Homestake Mining Company of California  
Grants Reclamation Project  
P.O. Box 98  
Grants, New Mexico 87020

Re: Homestake Mining Company – Grants Reclamation Site  
Evaporation Pond Investigations

**SUBJECT: REPORT OF 2016 ANNUAL INSPECTION OF TAILING IMPOUNDMENTS AND PONDS, HOMESTAKE GRANTS PROJECT, GRANTS, NEW MEXICO**

Figure 1 – Slumps below liner at east end of south inslope, EP1

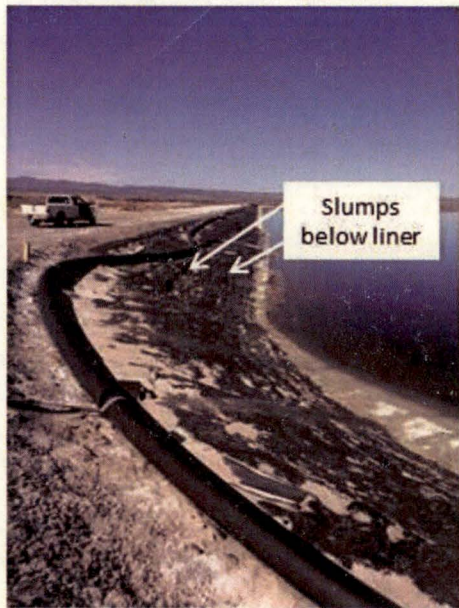
The small impoundment (location of evaporation pond #1, or EP1) remains in generally good condition. The slumps in the subgrade fill of the south inslope, under the pond liner along approximately 200 feet of the pond westward from the southeast corner (Figure 1), have not visibly changed from 2013 and the liner remains intact. With the pond water level much lower than normal for this time of year, more of this liner was visible and a second, lower slump was exposed approximately two vertical feet below the upper slump. Each slump is an irregular step or bench about 1-1.5 feet high. The function of the liner has not been compromised by this condition. However, weathering cracks have developed at several locations in this area (Figures 2 and 3), and although they do not yet appear to penetrate the entire thickness of the liner, it is likely that

The slump along the south inslope of EP1 should be protected against further displacement to protect the liner. In its present condition, the EP1 liner continues to be serviceable. Site staff should note any changes in the slump and the condition of the liner at that location.

Figure 2 – Cracks in liner at east end of south inslope, EP1

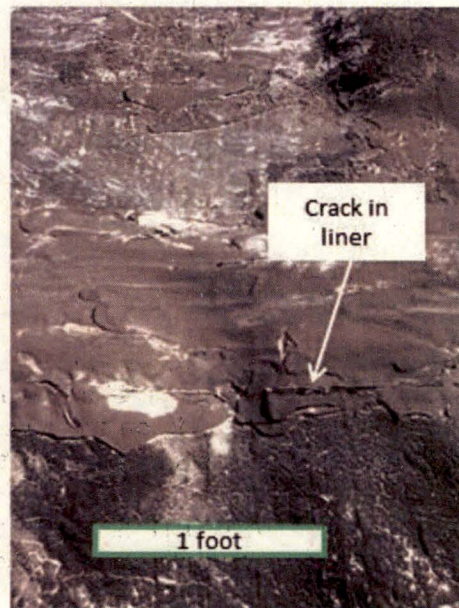
they will expand with time. While the water level was still relatively low and much of the liner on the slopes was exposed during October 2016, HMC personnel marked, cleaned and repaired (by application of hot asphaltic emulsion) cracks or tears in the liner above water level.
